DHDC 22-8136

CERTIFICATE OF APPROPRIATENESS (ADMINISTRATIVE APPROVAL)

RE: Application Number 22-8136; 2465 Chicago; Boston-Edison Historic District

PROJECT NAME: **MUSSAWIR RESIDENCE - PROPOSED RENOVATIONS**
2465 CHICAGO BOULEVARD, DETROIT, MI 48206
SHEET NAME: **EXISTING & PROPOSED EXTERIOR ELEVATIONS**

PROPOSED SECOND FLOOR PLAN / BALCONY PLAN
 SCALE: 1/4" = 1'-0"

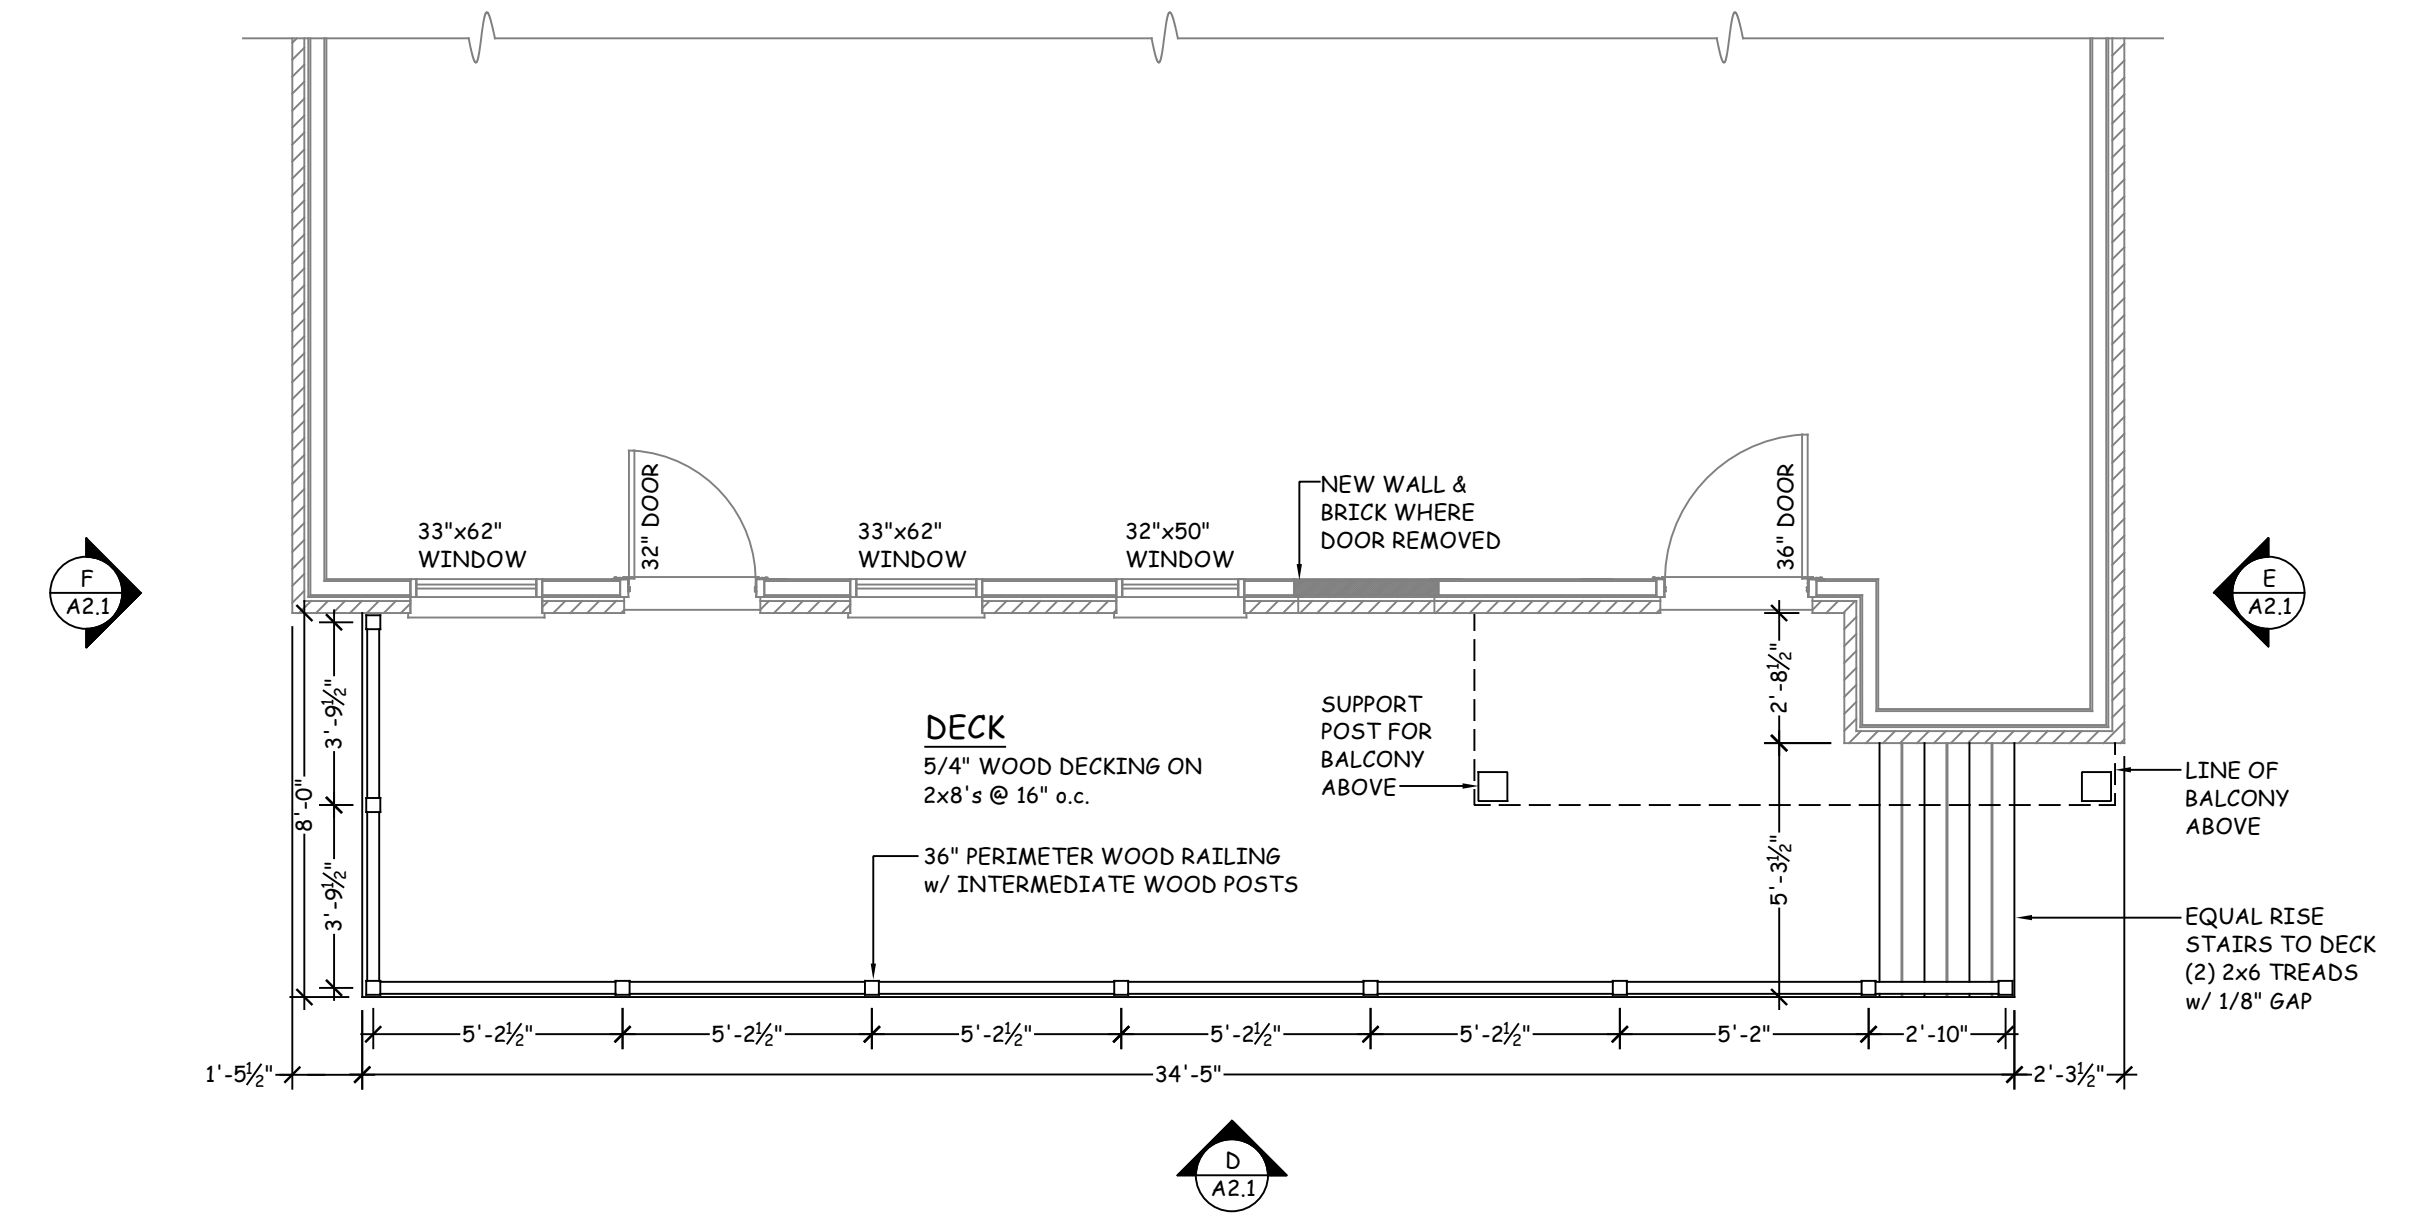
4. For the deck drawings, please clearly label that the drawings only pertain to the deck and balcony and no other feature of the house. Please cross off the windows and doors on the drawings. Please write the vertical dimensions of the deck and balcony on the elevations of the drawings. All of this can be done by hand on the existing drawings or the drawings can be revised and returned to us.
5. Please provide the paint color(s) for all painted surfaces, soffits, trim, doors and rear decking, balcony, rails and steps. Please select from the trim colors from Color System C in the attached brochure. Please let me know if you need assistance with this.

THESE DRAWINGS ONLY PERTAIN TO THE DECK & BALCONY AND NO OTHER FEATURES OF THE HOME
